NAVSHIPS 0967-066-7360

ELECTRONICS FIELD CHANGE BULLETIN
NAVAL SHIP SYSTEMS COMMAND
DEPARTMENT OF THE NAVY
WASHINGTON, D.C. 20360

Field Change 28-AN/URC-32, 14-AN/URC-32A,
11-AN/URC-32B—Modification to FSK Circuit, Type II,
Class A; 1 Manhour Required: Routine Action

Figure 1. Modified Converter-Monitor CV-730/URC, Provides FSK Reversal—Mark Low, Space Hi. Unit 5, AN/URC-32, -32A, -32B Partial Schematic.

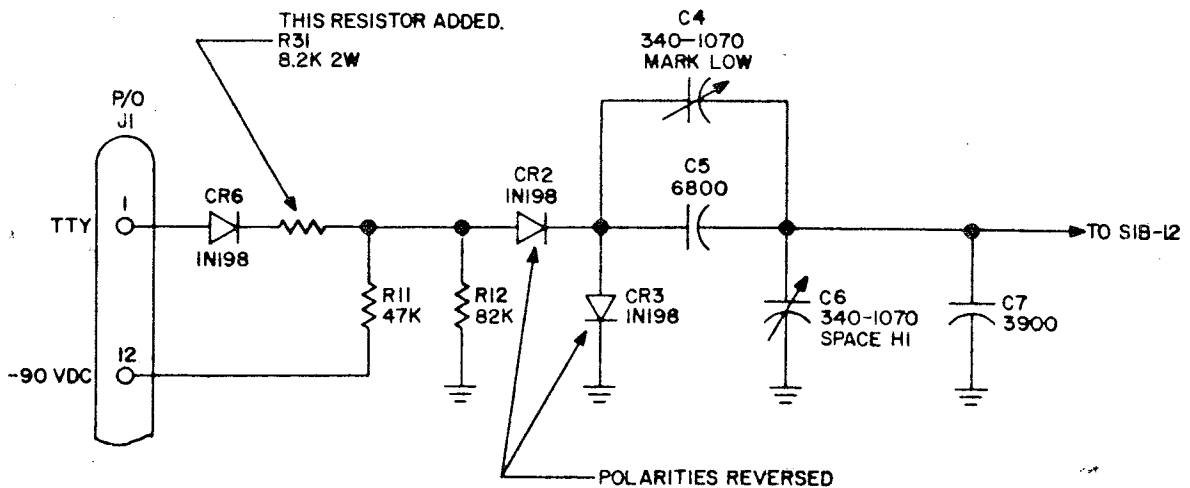
The purpose of this field change is to modify the frequency shift keying (FSK) mode of operation to position the space frequency 2425Hz above the carrier frequency, and the mark frequency 1575Hz above the carrier frequency.

This field change can be identified by the presence of an 8200 ohm resistor in series with diode 5CR6. Field Change 7-AN/URC-32, NAVSHIPS 0967-066-7140, must be accomplished prior to installing this field change. No requisite field changes are required to the AN/URC-32A or AN/URC-32B. Equipment nomenclature is not affected.

Material Required: Resistor 8,200 ohms, 2 watt, RC42GF822J, FSN 9N5905-192-4504.

1. Refer to figure 1 of this change and technical manual NAVSHIPS 0967-066-7010, figure 5-63 and 5-119 and proceed as follows:

2. De-energize and secure all power to the equipment.
3. Remove the two retaining screws on the convertor monitor, CV-730/URC chassis, and swing chassis away from frame. Remove P1, P2 and P3 from J1, J2 and J3.
4. Remove rear dust cover.
5. Disconnect CR6 and CR2 from the standoff to which R11, R12, CR2 and CR6 are connected.
6. Connect R31, 8200 ohms, to the standoff described in step 5.
7. Splice the free ends of CR6 and R31 and solder.
8. Disconnect CR3 from ground lug.
9. Connect CR3 to standoff described in step 5; solder CR3 and R31.
10. Connect CR2 to ground lug described in step 8.
11. Install rear dust cover.
12. Secure CV-730/URC chassis to main frame.
13. Remove the front dust cover.
14. Locate FSK freq. adj. controls C4 and C6. Remove the word (hi) located near C6 and remove the word (low) located near C4.
15. Return the equipment to normal operation.

16. Refer to Maintenance Standards Book for Radio Set AN/URC-32, 32A, -32B, NAVSHIPS 0967-066-7060, section B, step 2 and perform the indicated test. Note that the space frequency is 2425Hz and the mark frequency is 1575Hz, after the field change is accomplished.
